Comments received 15/06/2021 from Jonathan Markwell

Relating to condition submission application (210284)

JM comments followed by AB comments in red

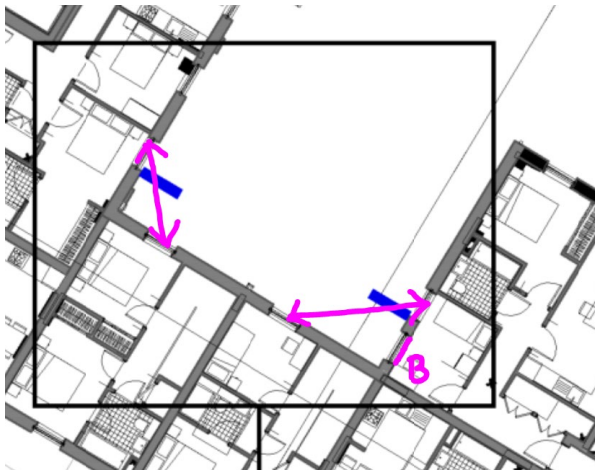
I can advise that when comparing p151 of the DAS at the time of application 170509 and the plan submitted in seeking to support this discharge of condition application, it is first noted that the internal layout of the western most unit has changed. The position of the proposed privacy screens do not actually serve any meaningful purpose, in that direct overlooking between the two opposite bedrooms is possible (and there is no way of addressing that, unless the second window in the single bedroom is removed). In the circumstances, I would suggest that the privacy screens are revised to the locations originally proposed, with that currently proposed on the western block retained, but that on the eastern side of the extract removed, making the proposal as follows (see a somewhat crude marked up plan below):

I can confirm the floor plan has changed as agreed under NMA 200228 when we amended the fire strategy. In my mind the purpose of these screens is to minimise close quarter overlooked between the dwellings. If we move these screens to the location you demark I question if this will achieve this as successfully as where previously proposed? See below a markup of how the proposed screens will work and assist in screening this overlooking. The window marked with a B would need to have a blind or curtain or similar however the location of the screen externally in the location shown will allow the other to not require this element.
